Brisbane Central Business District Bicycle User Group

The CBD BUG is once again writing to you, requesting that in your capacity as the Premier of Queensland you intervene with regard to the Queens Wharf (QW) development and the Bicentennial Bikeway. We know that during the Covid-19 pandemic your attention is focused elsewhere but the issues regarding Queens Wharf have not been resolved and construction is continuing to occur.

Victoria Bridge to Queens Wharf Plaza

Figure 1- AustRoads flow chart.

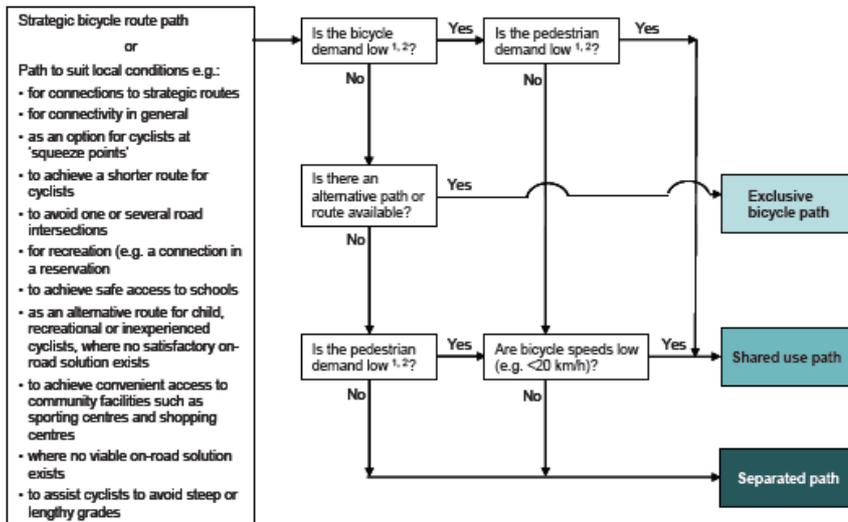
The proposed works as suggested by EDQ and QW do not comply with either TMR or AustRoads guidelines. AustRoad's "Guide to Road Design – Part 6A: Pedestrian & cyclist Paths" has a very simple diagram on page 7 (Figure 1). This clearly shows that a segregated path is the recommended solution. TMR's "Road Planning and Design ManualPart 6A" further expands on this guidance in a table (Figure 2). Once again the proposal is not in compliance with the guidelines. The CBD BUG finds it quite extraordinary that a Government department would fail to comply with official documents of another Government Department whose role is the design & installation of safe high quality cycling infrastructure.
